**County of Loudoun**  
**Department of Planning**  
**MEMORANDUM**

**DATE:** April 20 , 2007

**FROM:** Michael "Miguel" Salinas, Senior Planner *MS*  
Community Planning

**SUBJECT: ZMAP 2006-0024, SPEX 2006-0037, SPEX 2006-0038**  
**Community Corner**

**Graphic 3: Compatible screening of Service Area (Route 50 Corridor Design Guidelines, see attached)**

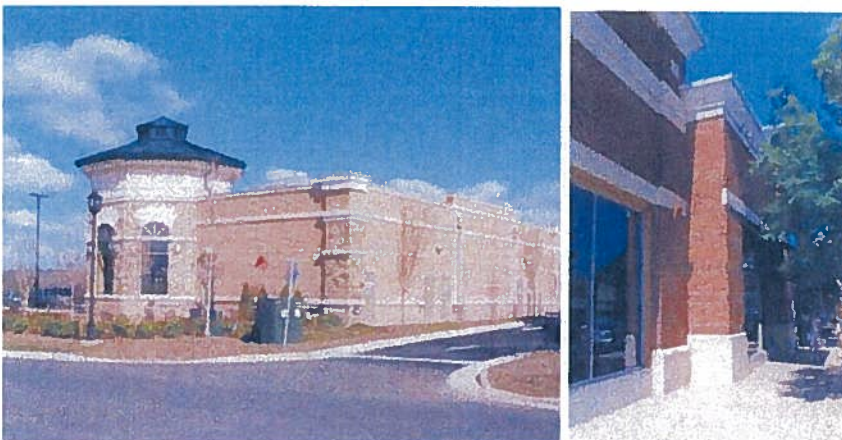
All retail centers should include a site design that is compact and makes buildings the prominent feature of the site as viewed from adjoining roads (*Countywide Retail Policy Plan Amendment, Policy 1, p. 20*). Parking areas should be visually screened from adjacent streets and/or residential areas (*Countywide Retail Policy Plan Amendment, Policy 3, p. 21*). Staff acknowledges the planned road alignments cited above divide the subject site in such a way to limit flexibility in building placement and compact design south of Tall Cedars Parkway and west of West Spine Road. Staff recommends, however, the applicant consider revising the Concept Development Plan (CDP) to reflect limiting the parking to the minimum required by the County (*Revised General Plan, Policy 1, p. 6-30*). By doing so, it may be possible for the building footprints proposed for the convenience store with gas pumps, the sit-down restaurant and the adjacent bank to relocate closer to the roadway – placing more of an emphasis on the buildings themselves and less on the parking as currently depicted in the CDP. Even if the minimum number of parking spaces is planned for the sit-down restaurant, the building footprint may be relocated closer to West Spine Road. Staff also

recommends the applicant commit to screening parking areas by providing a low screen, opaque wall or fence of a type consistent with the architectural features of the buildings, in combination with dense landscaping, adjacent to the front yard setback as shown in the CDP. Plan policies state that loading and storage areas must be screened from adjacent residential areas (*Countywide Retail Policy Plan Amendment, Policy 4, p. 21*). Staff recommends the applicant consider limiting loading, storage, and mechanical units along facades that are not visible from Tall Cedars Parkway and West Spine Road and screening these areas with masonry walls consistent with the building finish and design, and/or the use of landscaped areas and fencing (see Graphic 3 below as an example). Staff notes the CDP depicts parking stalls located adjacent to the front circulation drive south of Tall Cedars Parkway and is concerned about the conflict between the cars backing out of the stalls into oncoming automobile traffic. Lastly, large parking areas like the one associated with the sit-down restaurant should be landscaped with trees and shrubs to reduce its visual impact. Safe travel routes for the pedestrian should be provided from parking areas to the building with a demarcated pathway and clear directional signage (*Countywide Retail Policy Plan Amendment, Policy 1, p. 21*).

**Staff recommends the applicant: 1.) Revise the Concept Development Plan to reflect the minimum number of parking spaces required by the County. Doing so will create opportunities to relocate building footprints closer to the roadways, 2.) Locate the sit-down restaurant proposed adjacent to West Spine Road closer to the roadway in order to place the majority of the parking to the sides and rear of the building, 3.) Provide a conceptual landscape plan that commits to screening parking areas by providing a low, opaque wall or fence of a type consistent with the architectural features of the buildings, in combination with dense landscaping, adjacent to the front yard setback as shown in the CDP, 4.) Limit loading, storage, and mechanical units along facades that are not visible from Tall Cedars Parkway and West Spine Road and screen these areas with masonry walls consistent with the building finish and design, and/or the use of landscaped areas and fencing, 5.) Address the conflict between the vehicles backing from the parking stalls and vehicles traveling along the front circulation drive south of Tall Cedars Parkway, and 6.) Provide a conceptual landscape plan for the parking associated with the sit-down restaurant that enhances the large parking area and provides safe travel routes for the pedestrian from the parking areas to the building with a demarcated pathway and clear directional signage.**
